Our ref: GWA/106RPR/Ltr/01

Re: Replacement of vault roof at 106 Regent's Park Road

Root Excavation Report

Trial pit 1

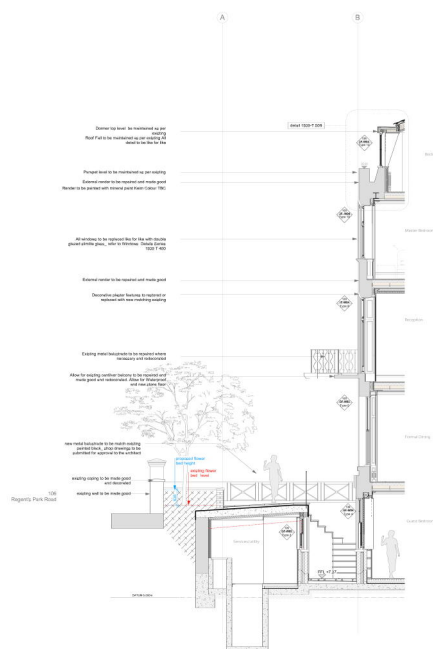
Trial Pit 1	<p>1.7m Long x 2.1m Wide x 0.1m Deep</p> <p>Trial pit finishes 1.8m from the edge of the paving</p> <p>1x100mm root</p> <p>3x45mm roots</p> <p>2x30mm roots</p> <p>Small mass of fibrous roots.</p> <p>No roots exceed 25mm at 1.8m from edge of light well</p>
-------------	---
